Project	IEEE 802.16 Broadband Wireless Access Working Group http://ieee802.org/16 >				
Title	Modified structure of the 802.16h Working Document 2006-05-11				
Date Submitted					
Source(s)	Wu Xuyong Huawei,	Voice: Fax:	+86 755 28780808		
	Huawei Industry Base Shenzhen, China	wuxuyong@	huawei.com		
Re:	IEEE 802.16h-06/011 – Working Group Review reviewing on C80216h-06_028 Modified structure of the 802.16h Working Document				
Abstract	Proposes a more logical structure which will allow better understanding of the existing mechanisms				
Purpose					
Notice	This document has been prepared to assist IEEE 802.16. It is offered as a basis for discussion and is not binding on the contributing individual(s) or organization(s). The material in this document is subject to change in form and content after further study. The contributor(s) reserve(s) the right to add, amend or withdraw material contained herein.

Modified structure of the 802.16h Working Document *Wu Xuyong (Huawei)*

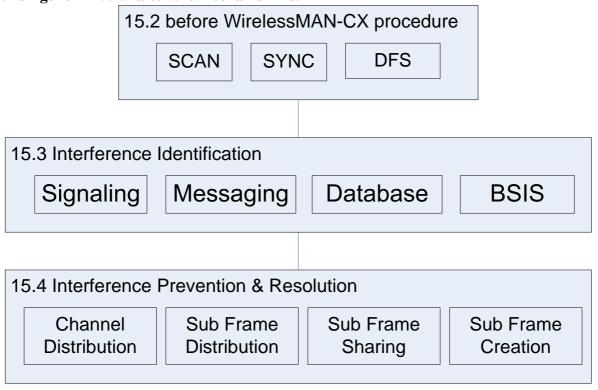
Insert this figure in 15.1.4 after the mechanism list
